Office Action Summary

10/688,261

HAHN, NORBERT

DETAILED ACTION

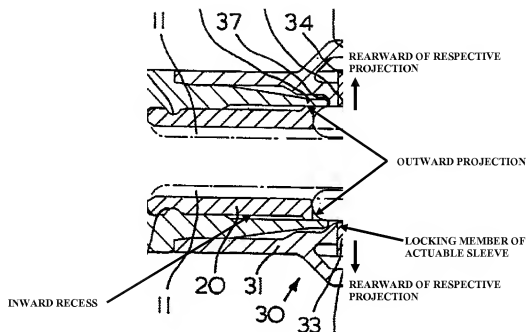
Regarding claims 1, 3, 4, 6, 7, 17, 18 and 33, Lauterwald discloses a tool holder that receives as tool 10, the tool holder comprising: a tubular main body 20; an elongated locking element 50, 60 mounted on the main body 20, the locking element 50, 60 having an engaging portion 62 forward of a pivot point that permits pivoting of the engaging portion 62 into engagement with a retaining collar¹ 41 to define a locked position (figure 2), and an unlocked position (figure 3) permitting a tool 10 to be inserted or removed from the main body 20; a manually actuable sleeve 30 mounted around the main body 20 so as to be axially movable between a first position in which the engaging portions 50 of the locking element 50, 60 are held in the locked position, and a second position in which the engaging portions 50 of the locking element 50, 60 are movable to an unlocked position; a retaining ring 41 axially slidable with respect to the main body 20 independent of movement of the actuable sleeve 30, and the retaining ring 41 is positioned rearward of the locking element 50, 60; and a spring member 49 that axially biases the retaining ring 41 forward into engagement with the locking element 50, 60

and a spring member 39 that biases the actuatable sleeve 30 into the locked position. The engaging portions of Lauterwald are positioned between an end of the main body distal to the forward end and the pivot point of the locking element, rather than being positioned between the forward end of the main body and the pivot point of the locking element.

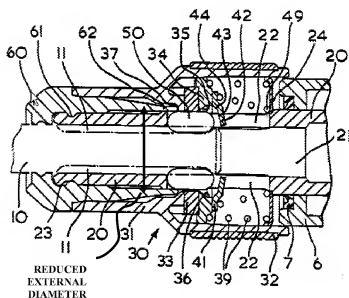
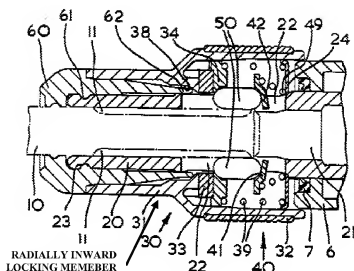
Regarding claims 12 and 13, the locking element 50, 60 of Lauterwald includes a portion positioned radially outward of the main body 20, and the actuable sleeve 30 includes a locking member radially inward of rear portion of the actuable sleeve 30, such that the locking member engages the radially outward portion of the locking element when the sleeve is in the locked position, and the locking member is radially outward of reduced external diameter portion of the locking element when the sleeve is in the unlocked position (see illustration below).

FIG. 2

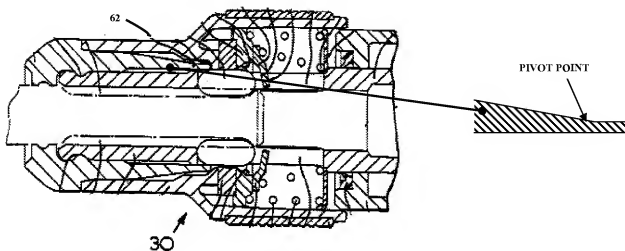
Applicant has argued that Lauterwald does not disclose a pivotable locking element. As presented in the rejection above, Examiner has found elements 62 of Lauterwald to pivot

between locked (figure 2) and unlocked (figure 4) positions. Below are illustrations depicting the pivotable movement of engaging portion 62 of the locking element disclosed by Lauterwald.
